The **City of Stoughton** will hold a **Joint Meeting** of the **Planning Commission and Business Park North Committee** on **Monday August 23, 2010 at 6:00 p.m.**, in the **Council Chambers**, Second Floor, **Public Safety Building**, 321 S. Fourth Street, Stoughton WI.

1. Call to Order
2. Elect Chair & Vice-Chair of the Business Park North Committee
3. Mark Halverson, Lean Distribution, LLC requests site plan approval for a building addition at 241 Business Park Circle, Stoughton Business Park.
4. Adjournment.

**PROPOSED
ADDITION
STOUGHTON, WI**

I have completed a review of the proposed addition at the Lean Distribution facility, 241 Business Park Circle - Plan submitted 8/18/10. As noted, additional information may be required to be provided or shown on the plan.

GENERAL SITE PLAN
SCALE: 1"=20'

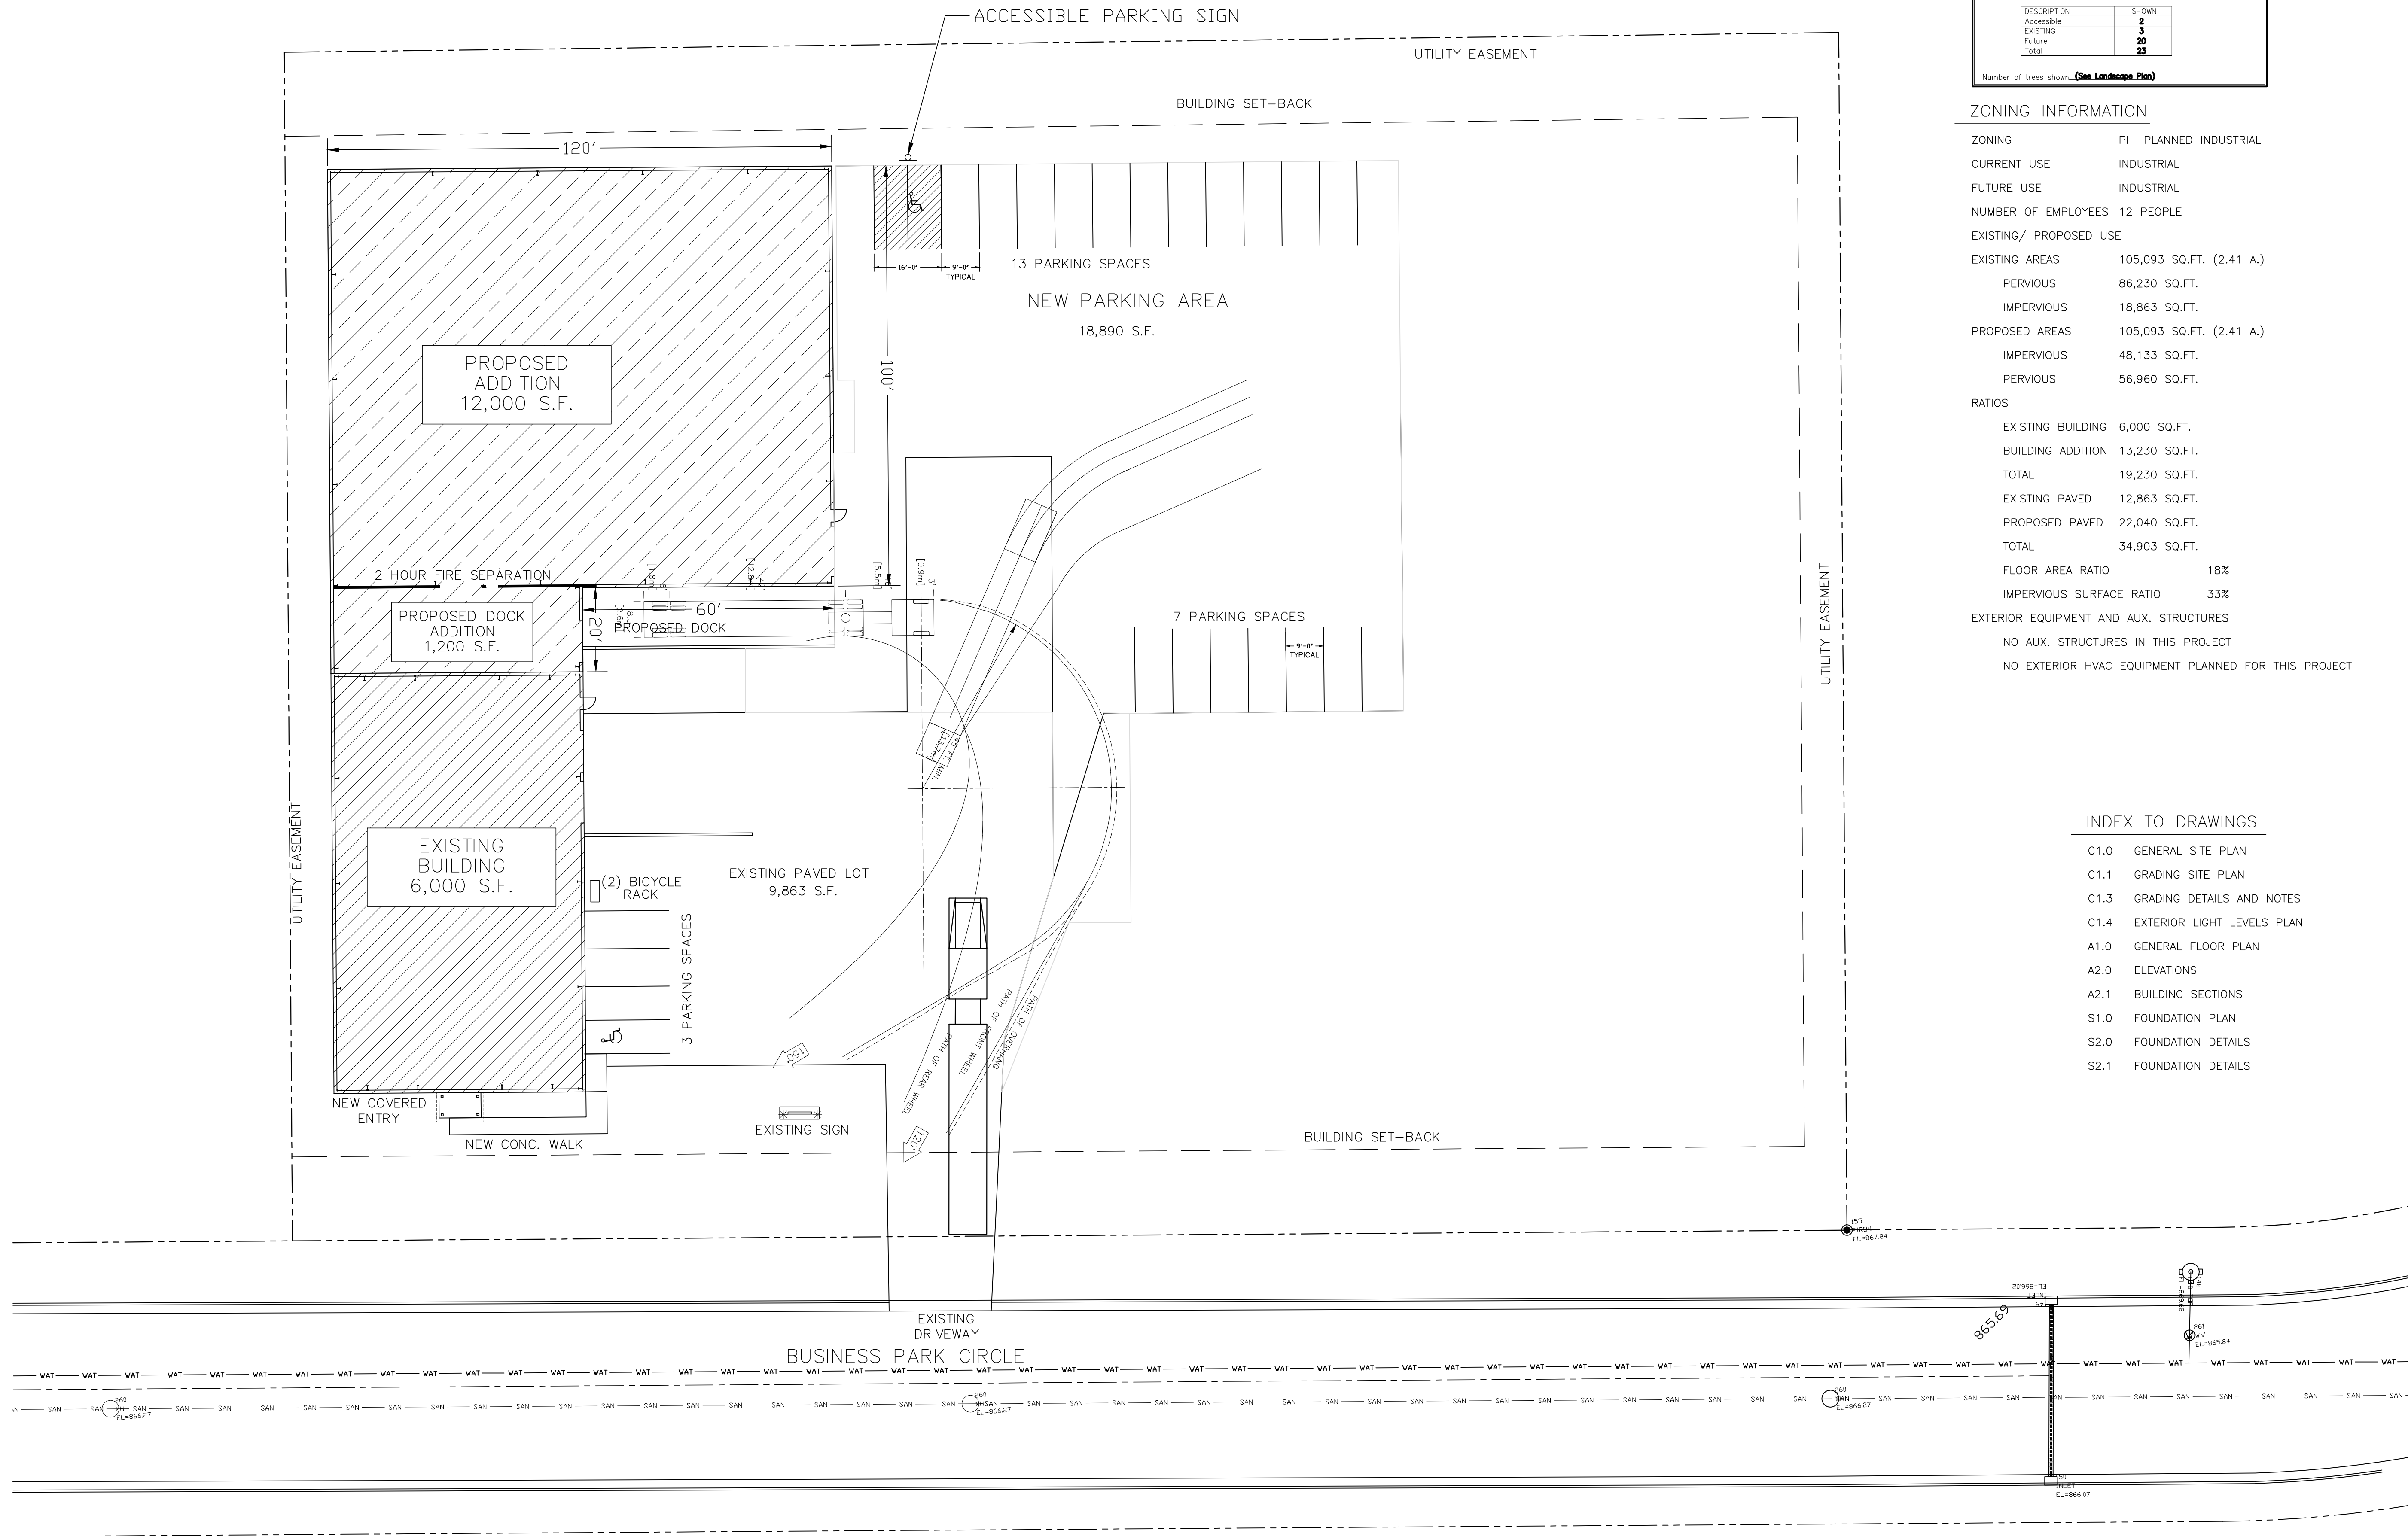
2. The parking requirement for light industrial land uses is one space per each employee on the largest work shift. There are twenty two parking spaces proposed. We have been informed by letter there are 12 existing employees with the potential to increase to 20 employees by 2012. **The proposed parking complies with this requirement.**

4. One off-street loading stall is required per section 78-705. **The proposed existing loading dock meets the loading requirements of Table 78-705(4). The truck turning radius is shown on the site plan.**

5. **A landscaping plan has been provided to meet the spirit of article VI of the city zoning code for the building addition. Some of the required paved area landscaping and building foundation landscaping has been provided elsewhere to provide for snow removal around the paved area and due to the lack of visible foundation area.**

7. Article VII of the city zoning code provides the following requirements related to the parking area: **“Parking spaces for vehicles exceeding 18 feet in length shall be clearly indicated on the site plan. All off-street parking and traffic circulation areas shall be completed prior to building occupancy. In no instance or manner shall any off-street parking or traffic circulation area be used as a storage area. Parking stalls shall be marked in a manner which clearly indicates required parking stalls. Parking stalls are required to be 9 feet wide and 18 feet long.”** The parking stall size complies with this requirement. We have been informed that all operations including storage will be internal.

9. **Details will need to be provided describing how trash is handled for the facility. We have been informed that a dumpster is not needed on-site. A dumpster enclosure is necessary for any future dumpster located on-site.**

11. The building addition meets the setback and height requirements of the Planned Industrial district.
12. A stormwater management and erosion control plan, application and fee are required. Dane County Land Conservation, the City’s consultant, will review the plan and perform inspections. **The plan, application and fee shall be submitted to the Department of Planning & Development office at City Hall. There will need to be more details related to the roof drainage, piping and infiltration trench along the west property line to prevent damage to the adjacent property.**

13. Proposed utilities-including electrical transformers and HVAC locations shall be shown on the plan. **The utilities are delineated on the plan. Stoughton Utilities requires any unused laterals to be abandoned.**

Project 10-020	Sheet C1.4
Date 4.27.10	
Scale NOTED	
FILE AUTOCAD DRAWINGS-10\FRIEDE\10-020.DWG

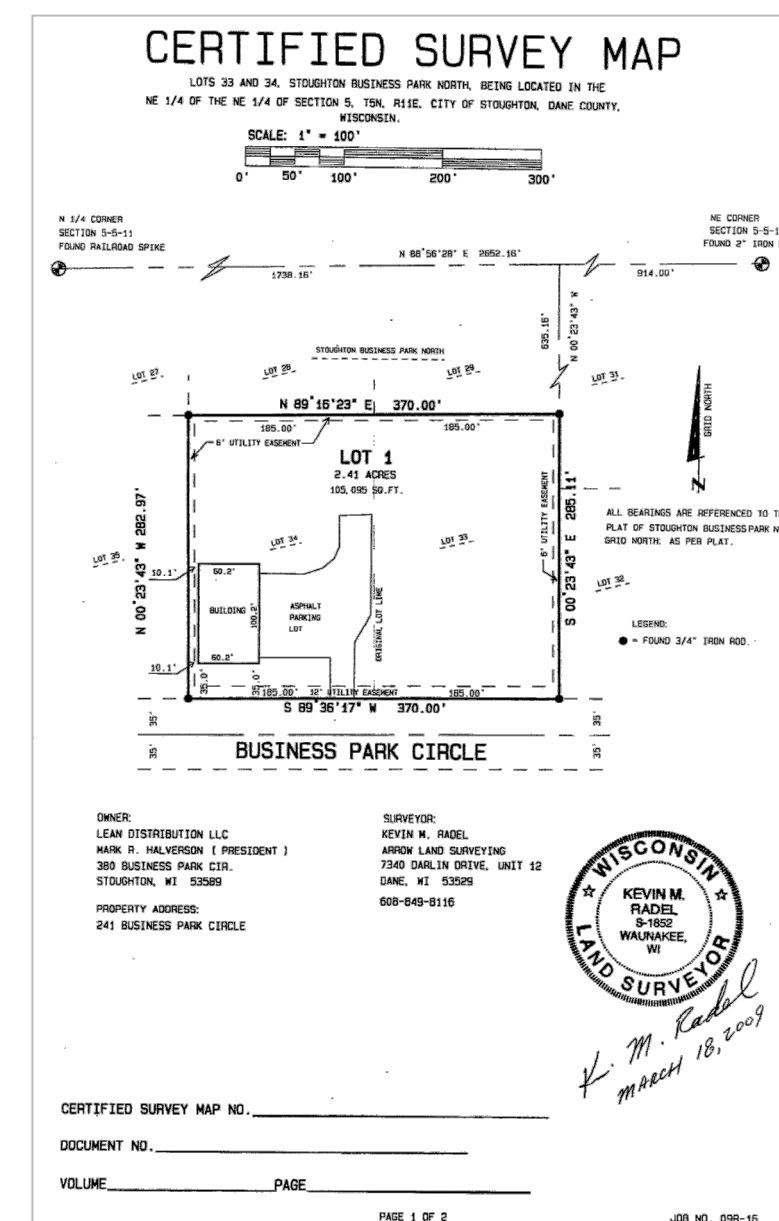
8. Article VII of the city zoning code provides the following requirements related to lighting: **“Parking and traffic circulation areas serving 6 or more vehicles shall be lit so as to ensure the safe and efficient use of said areas during the hours of use. An illumination level of between 0.4 and 1.0 footcandles is recommended for said areas, and said illumination shall not exceed 0.5 footcandles measured at the property lines.”** This requirement is not necessary if the parking, loading and circulation areas are not used after sunset. We have been informed that the facility is not used after sunset.

10. Section 78-707, Exterior lighting standards, requires a maximum average on-site lighting of 2.4 footcandles. The maximum lighting as measured at the property line is 0.5 footcandles. **The proposed wall pack lights are compliant.**

- d. Exterior Lighting. **A compliant photometric plan has been provided.**
- e. Clearing, grading, and drainage plan showing proposed clearing limits, existing and proposed contours at two foot intervals. **The provided grading plan with one foot contours is sufficient to meet this requirement.**
- f. Site statistics, including site square footage, percent of site coverage's and percent of park or open space. **Provided on site plan.**
- g. All exterior materials and colors, including manufacturer's name and catalogue numbers or samples of the same. **The proposal is to match the existing building.**
- h. Location and dimensions of all proposed outdoor storage areas, and the location and dimensions of all fencing and screening. **No outdoor storage or fencing is proposed.**
